Final Drainage Report

High Forest Estates Subdivision Filing No. 1

PCD File No. VR2311

January 17, 2024

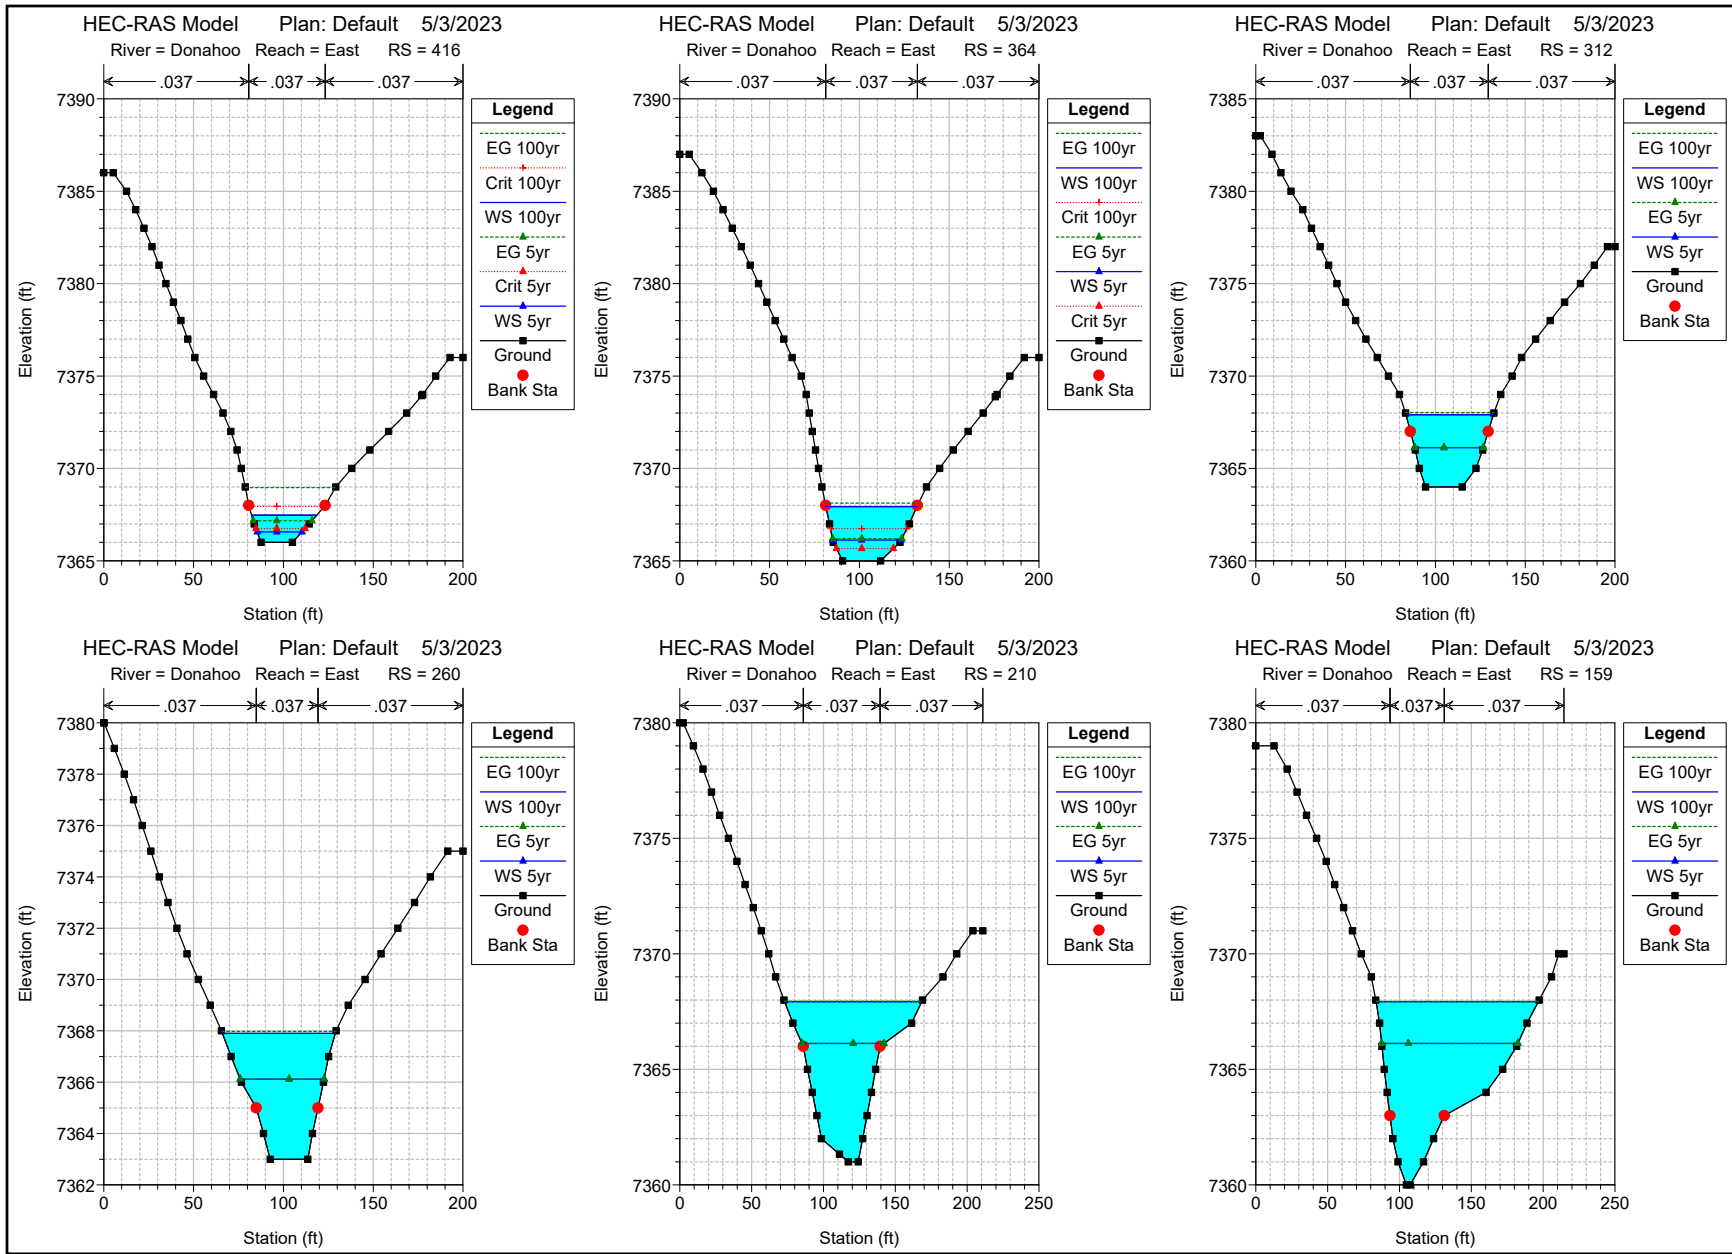
Froude #s and velocity exceed criteria in certain sections. Please see modeling sheet and provide solutions to correct issue.

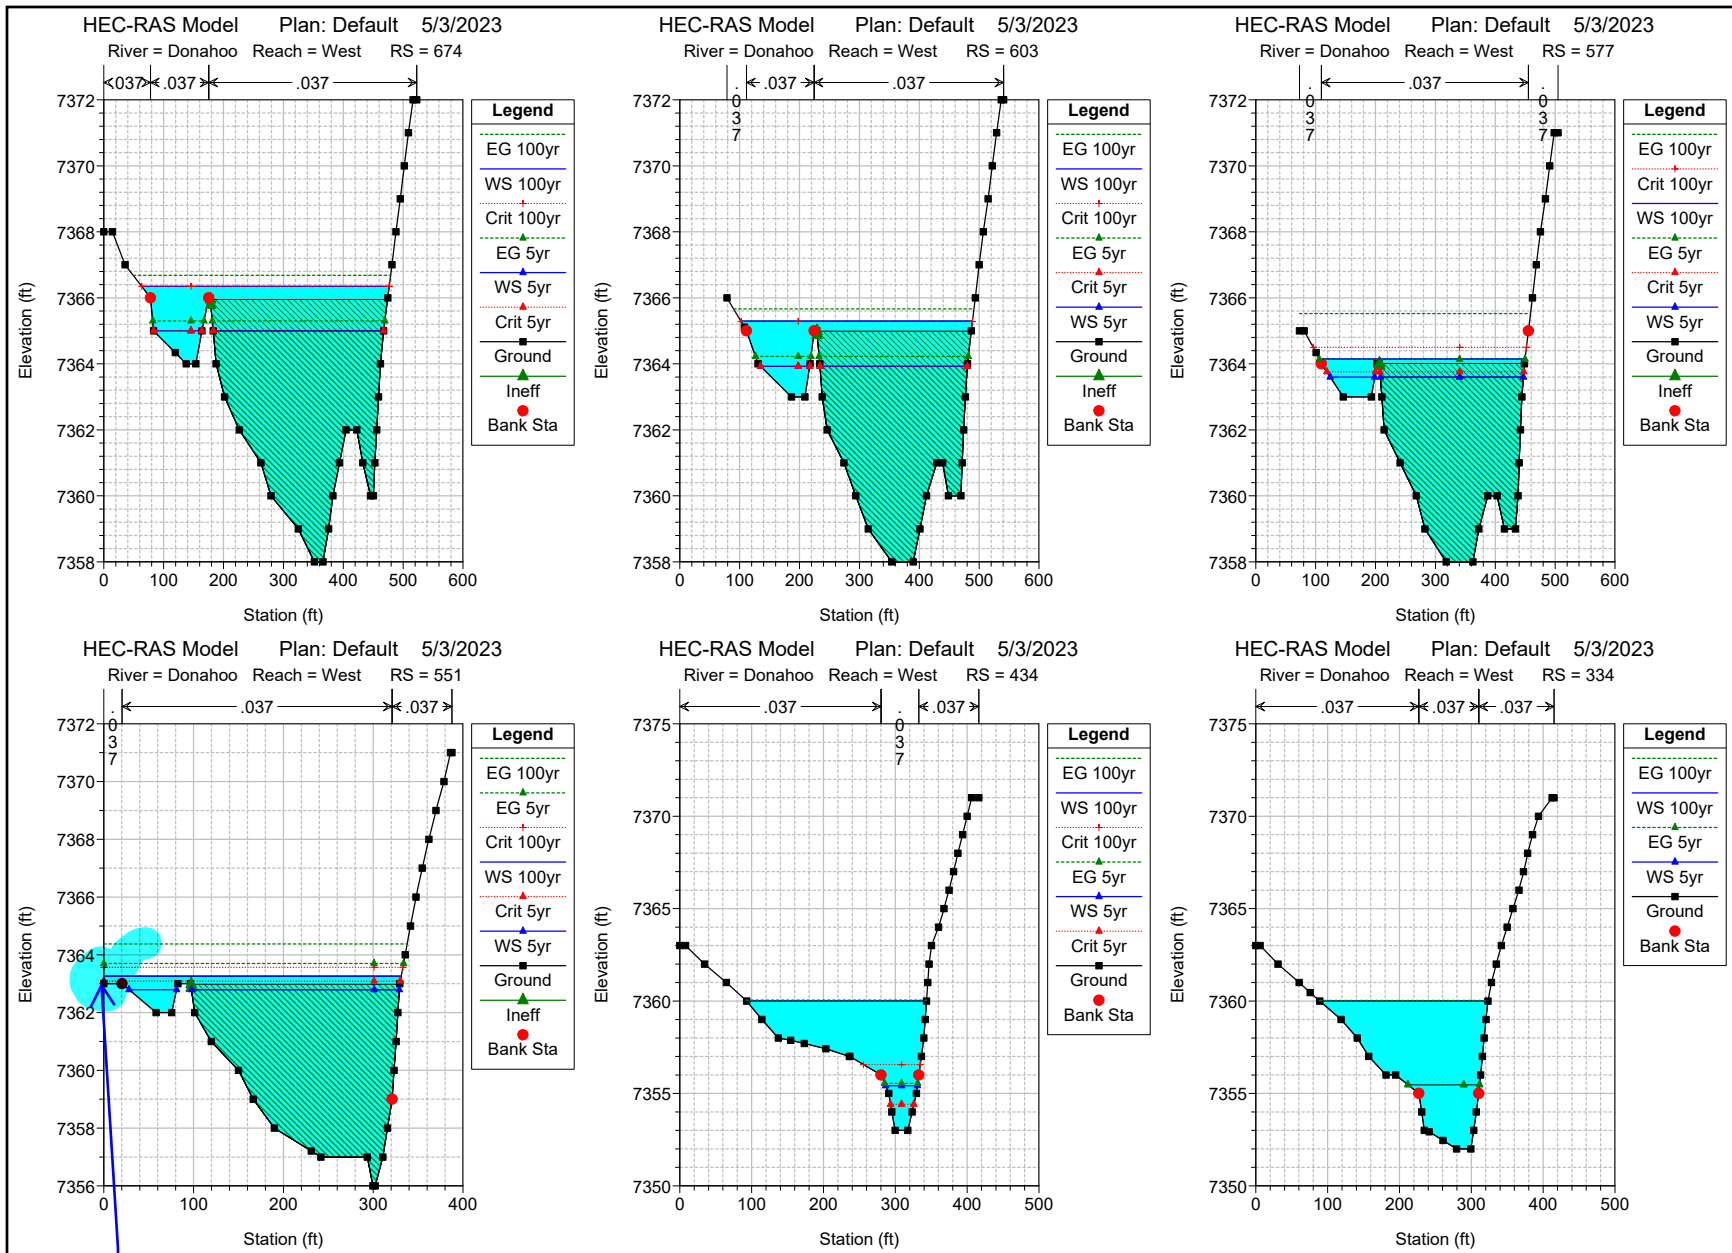
Extend
cross-section

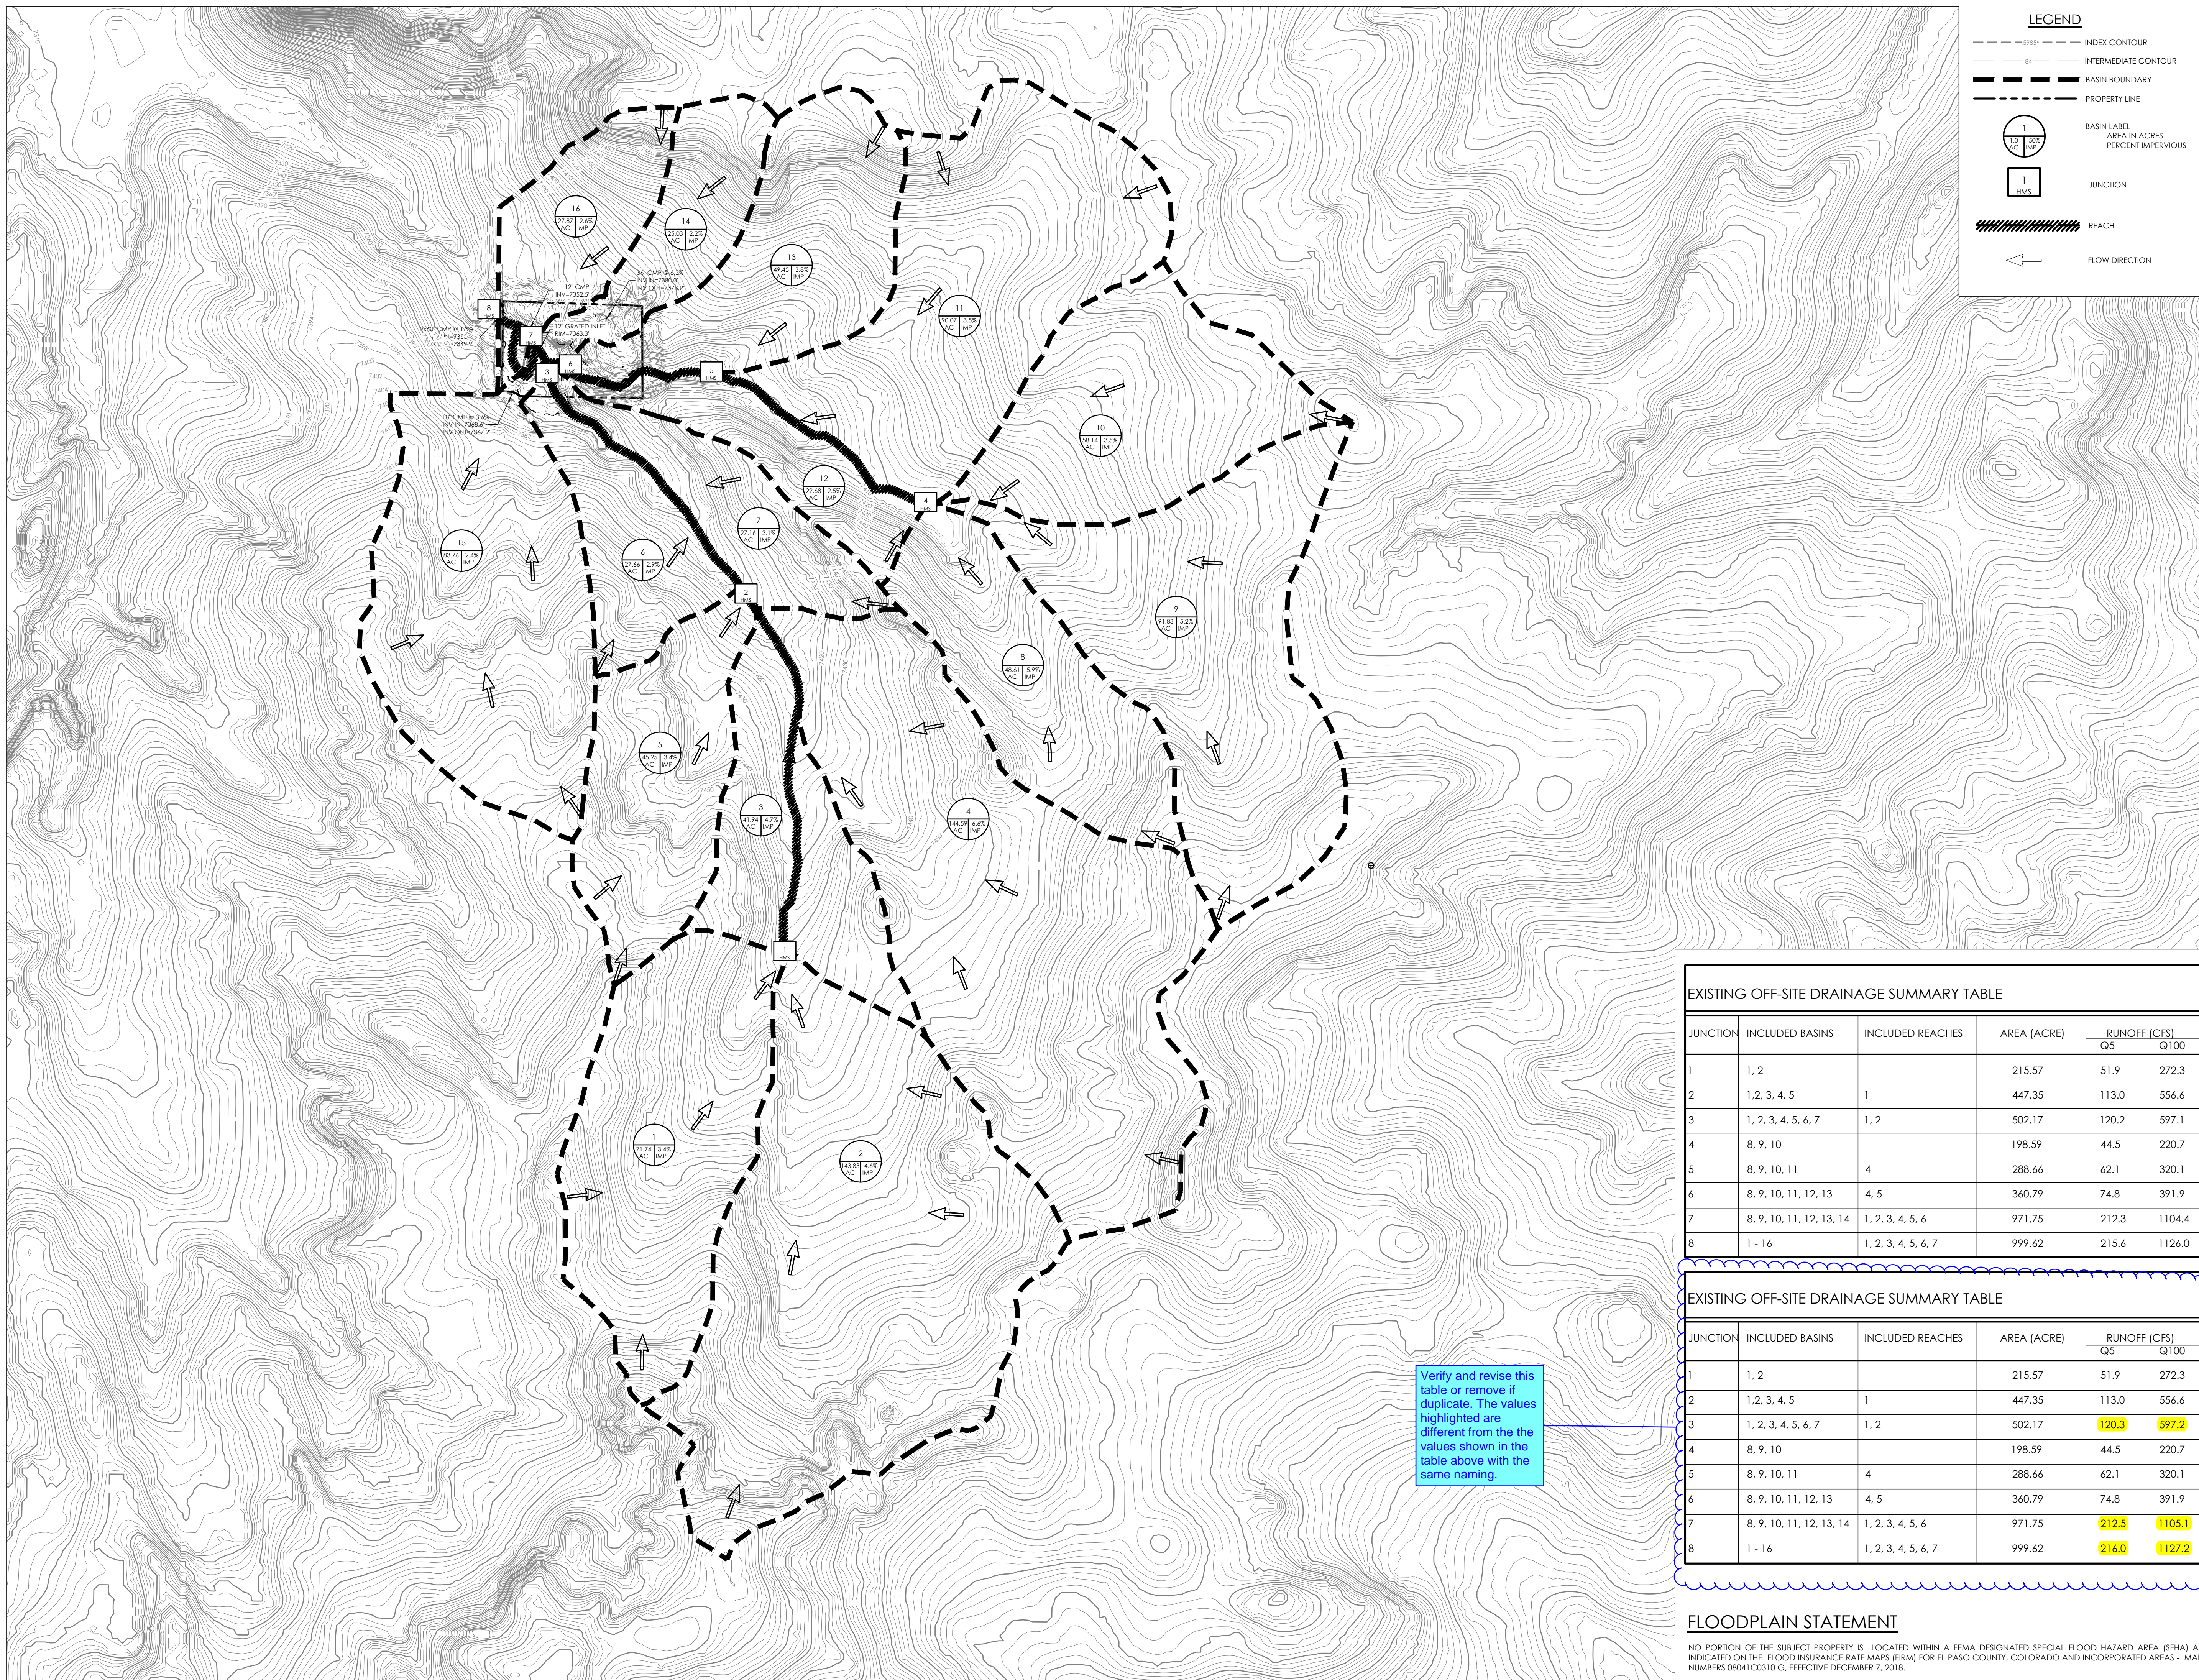
Verify and revise this table or remove if duplicate. The values highlighted are different from the values shown in the table above with the same naming.
